**STAFF REPORT
HISTORIC AND CULTURAL LANDMARKS COMMISSION
CITY OF FORT WORTH, TEXAS**

DATE: June 12, 2017

| LOCATION | 2400 Cass Street |

Applicant requests a Certificate of Appropriateness to construct a single-story residence.

Figure 2. Site Plan

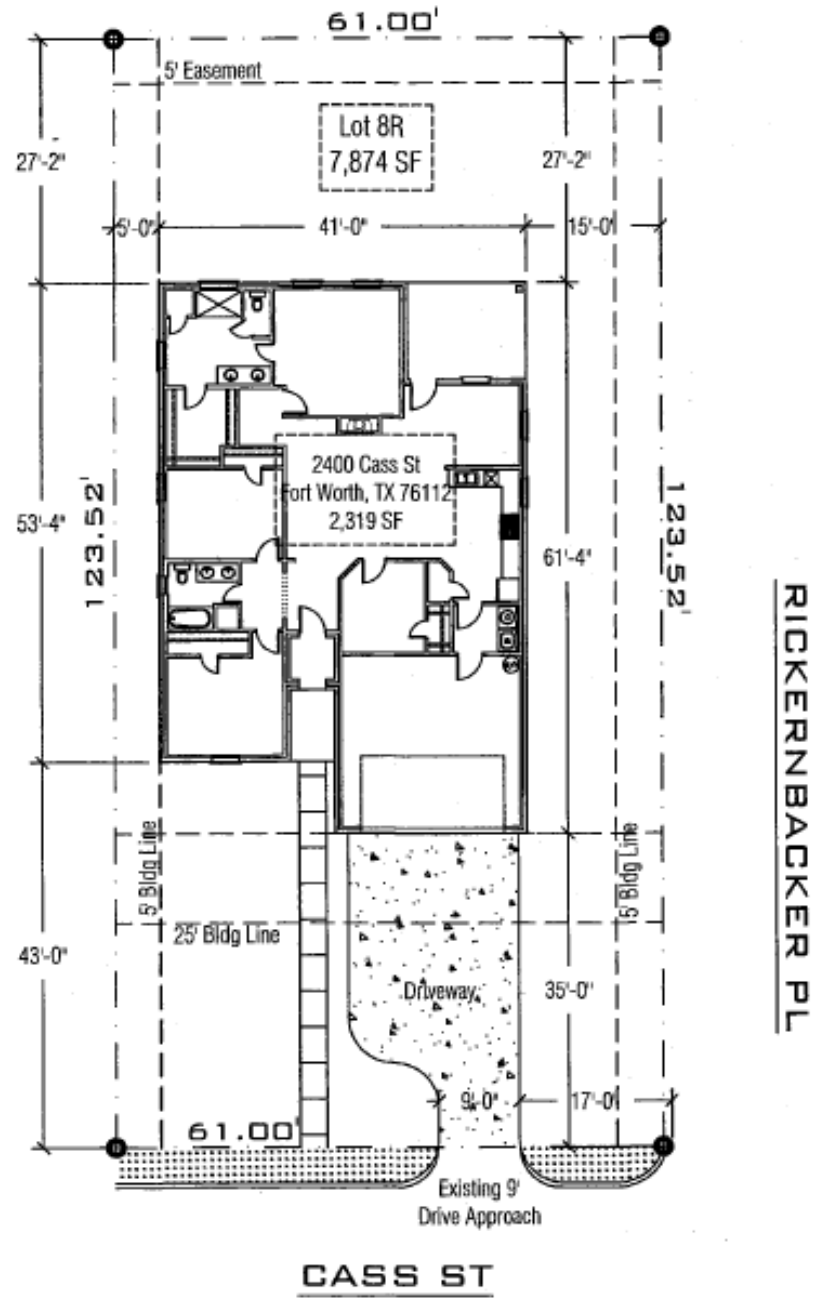
The attached garage is appropriate for the District, however, the two-car garage occupies over 52% of the front and while the driveway approach is consistent with the predominant width of driveway approaches along the street, the driveway width itself is inconsistent with the predominant width of driveways along Cass Street. The predominant character of Cass Street features attached carports and single-car garages that are subordinate architectural elements incorporated into the design. The proposed proportionality has a considerable impact on the character of the streetscape and as a result, is considered to overwhelm the remaining living space across the front.

- 2. That the garage be incorporated in a manner that is more consistent with the predominant character of Cass Street by reducing the driveway width and the overwhelming effect of the garage;**

Figure 7. Front (East) Elevation

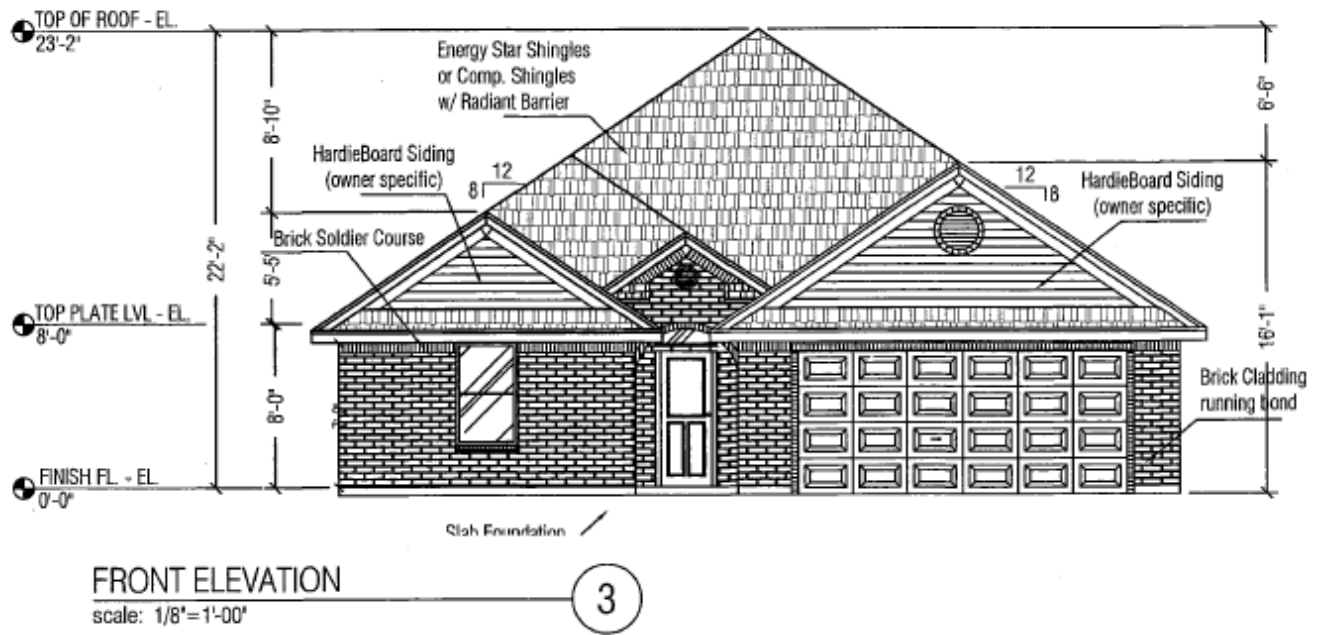
The size and proportion of proposed windows on the front elevation and the tangential left and right side elevations that would be highly visible from Cass Street and Rickenbacker Place respectively, are less than the predominant size and proportion of windows along the street, particularly the front elevation, owing in large part to the area that is occupied by the garage door.

The steeply-pitched hipped roof is inconsistent with the predominant character of low-pitched gable roof pitches along Cass Street. The use of brick cladding is inconsistent with the predominant exterior wall materials that form the streetscape character in the area.

- 1. That the area of windows facing Cass Street and Rickenbacker Place be increased to be more consistent with the predominant area of windows facing a front and flanking street respectively;**

- 3. That the roof pitch be reduced to be more consistent with the predominant roof pitches along Cass Street;**
- 4. That the proportion of horizontal siding facing Cass Street and Rickenbacker Place be increased to be more consistent with the predominant use of materials along Cass Street;**
